# **Guiding Eyes for the Blind**

Re: Mongero Site Plan Amendment

TO: Planning Board  
FROM: Yorktown Trail Town Committee  
RE: Mongero property  
DATE: December 8 2021

## LANDSCAPING & PLANTING FOR MITIGATION PLAN

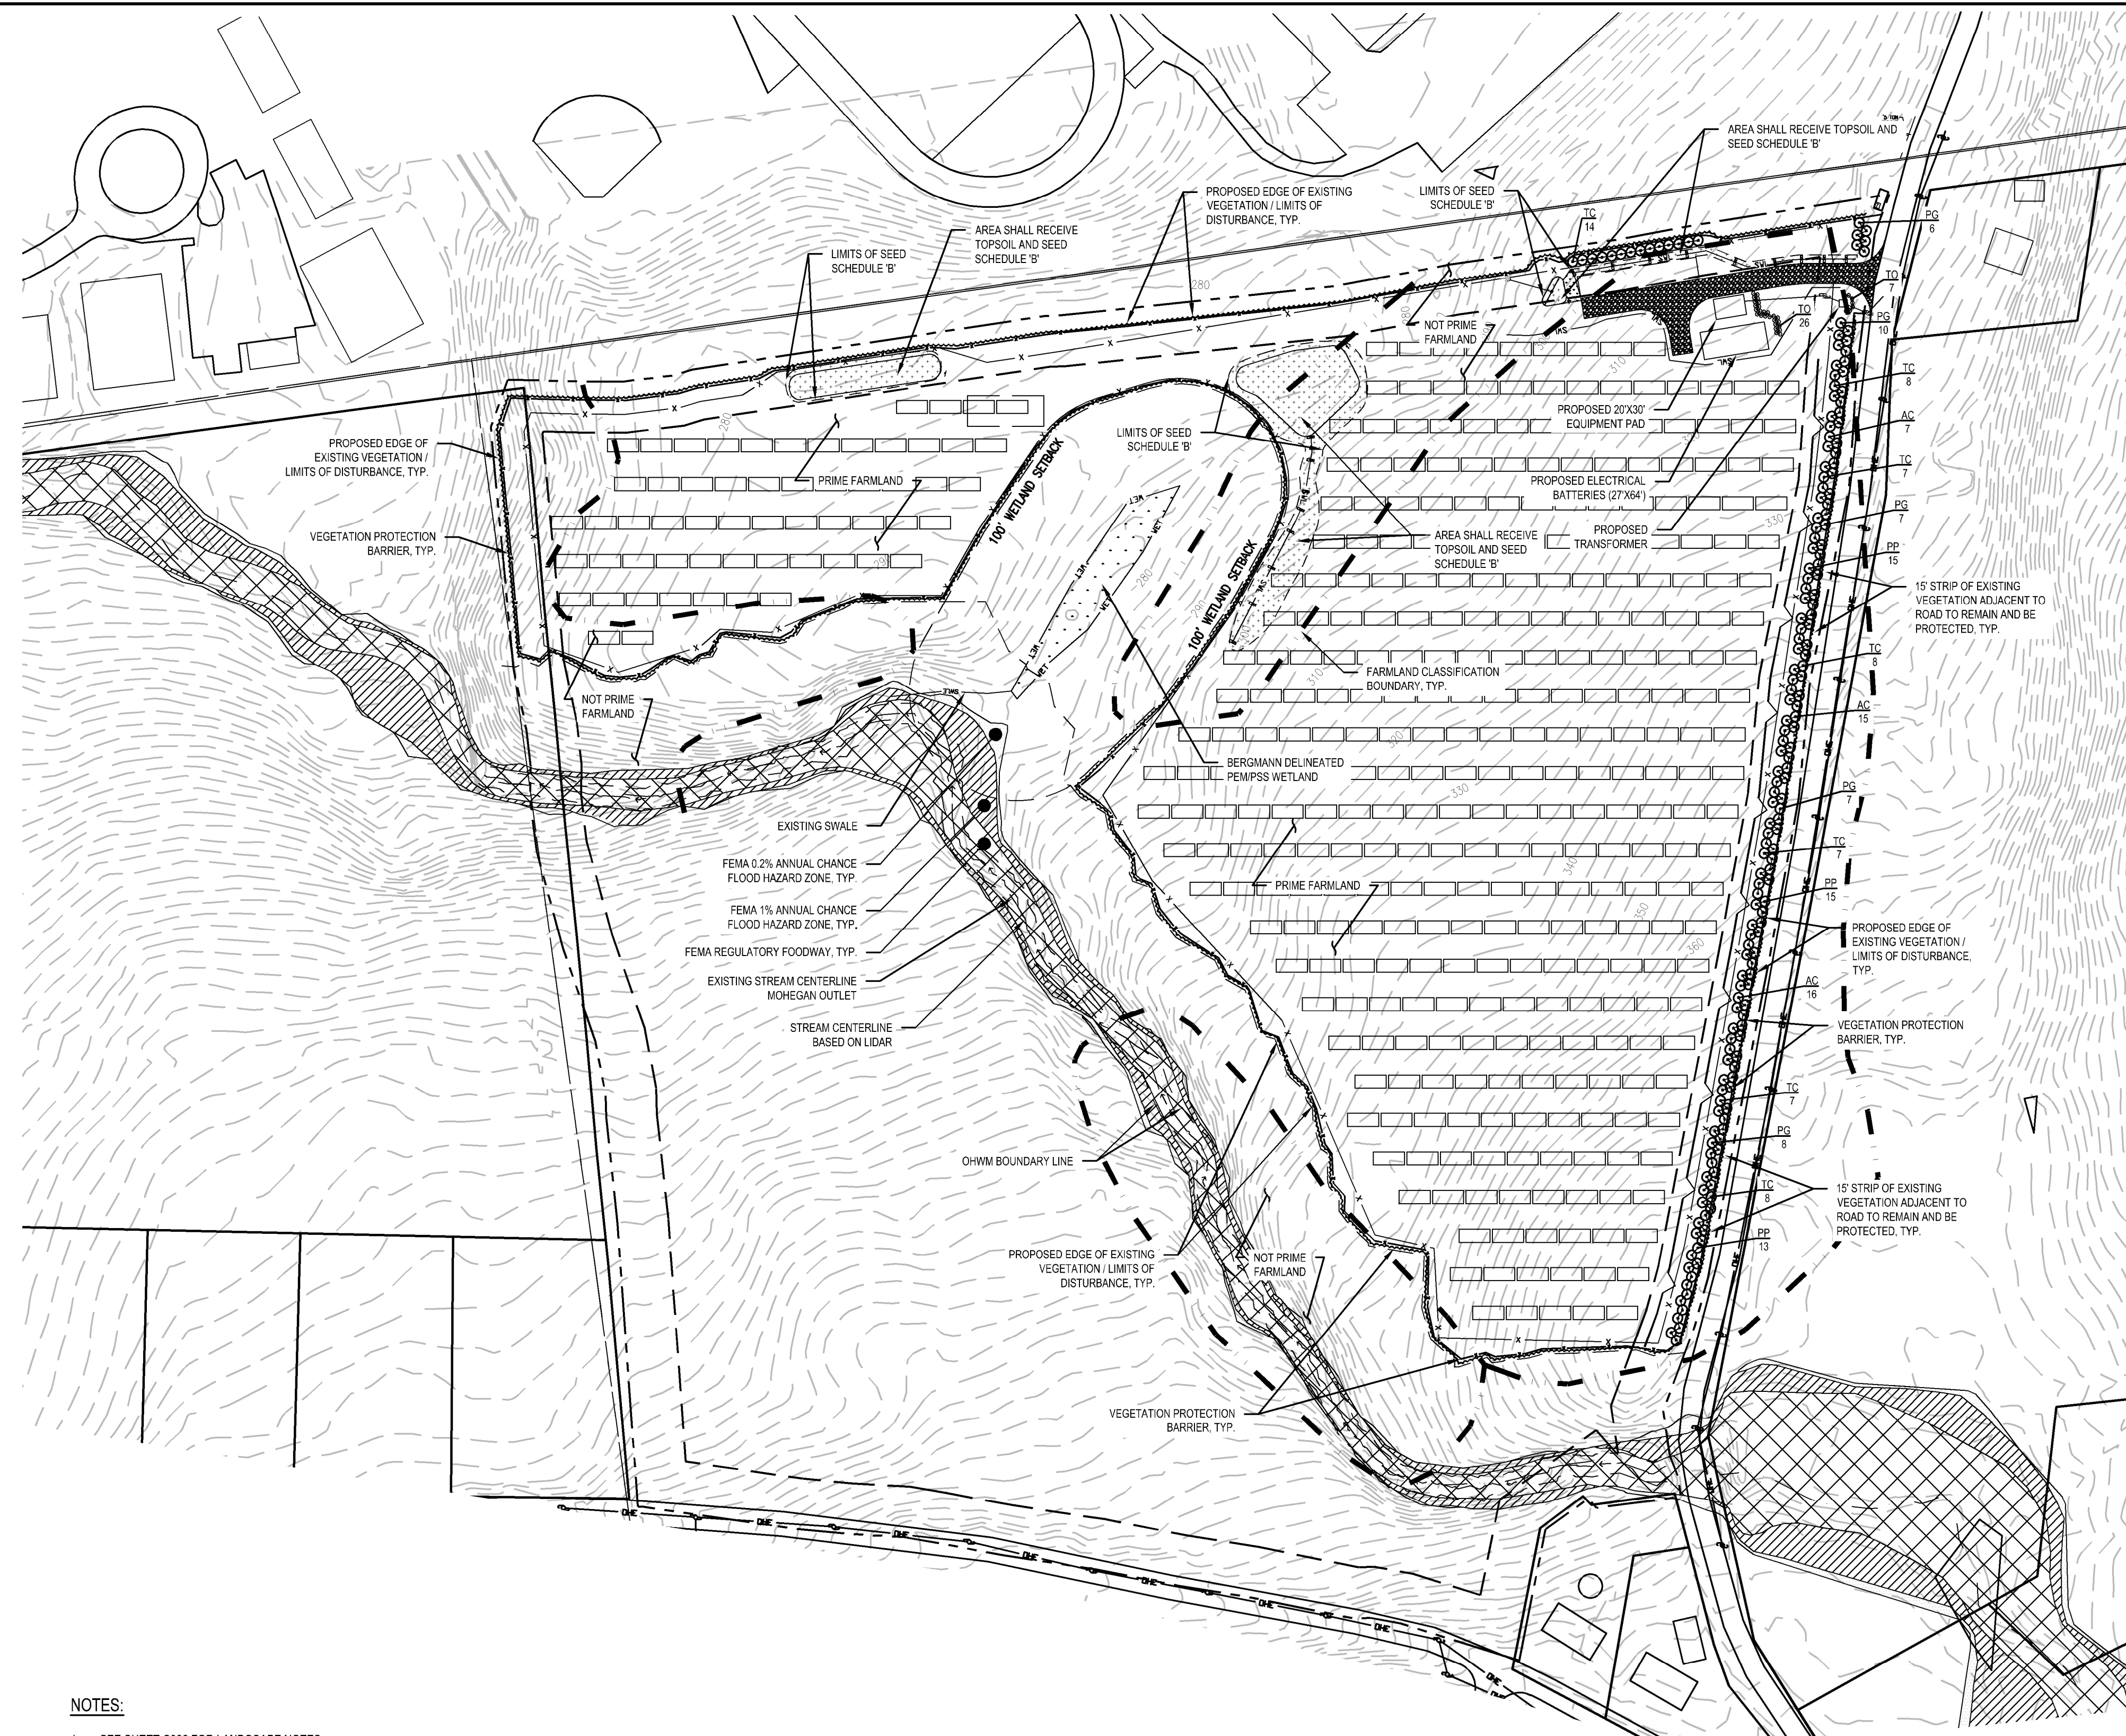
1. The submittal includes a drawing C006 – LANDSCAPING & PLANTING FOR MITIGATION PLAN. This plan shows the developer is proposing to plant 179 evergreen trees and 33 evergreen shrubs. Considering that a very large number of trees are to be removed and significant protected woodlands will be disturbed, the TCAC's position is that this mitigation is inadequate. Chapter 270-10.B.(1) states "All nonadministrative permits require mitigation." Chapter 270-10.D.(1) states "The approval authority shall require the preparation of a mitigation plan .....". According to Chapter 270-4's definition of a MITIGATION PLAN states ".... The goal of such plan is to replace the functions carried out by the protected trees and woodlands affected by the proposed activity." A revised mitigation plan must be submitted. Chapter 270-10.C.(1) through (5) gives options for mitigation.

2. Furthermore, drawing C006 shows the proposed plantings "INSTALLED SIZE" in heights not DBH. This needs to be corrected so that a mitigation ration (sic) can be calculated.
